IMPORTANT SAFETY RECALL

NHTSA RECALL: 21V786
CANADA RECALL: 2021-622
FR ID: 05-0171

DEFECT/NONCOMPLIANCE:

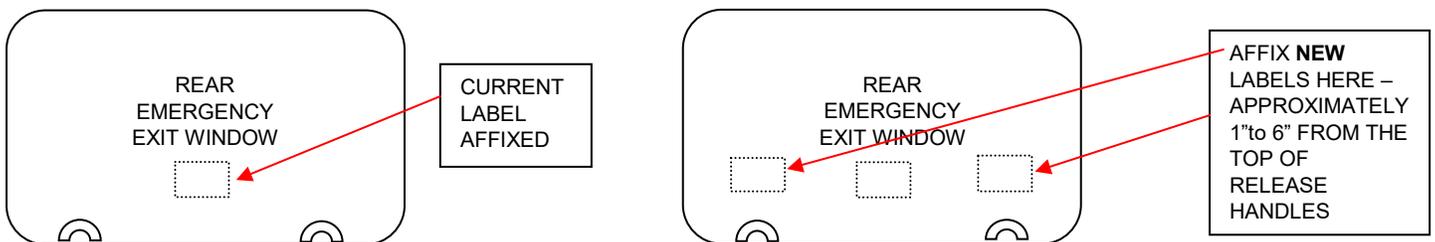
The rear emergency exit window labels are not within 16cm of the release mechanisms, and the instructions are incomplete as they only reference one single handle

If the passenger follows the instructions on the label, a passenger would operate one release mechanism resulting in the second release mechanism to remain latched. Therefore, the window may not be able to pushed out in an emergency potentially causing personal injury.

Dealership Service Department Service procedures are included below. Please contact the phone number below to order the stickers. 2 stickers will be needed for each window.
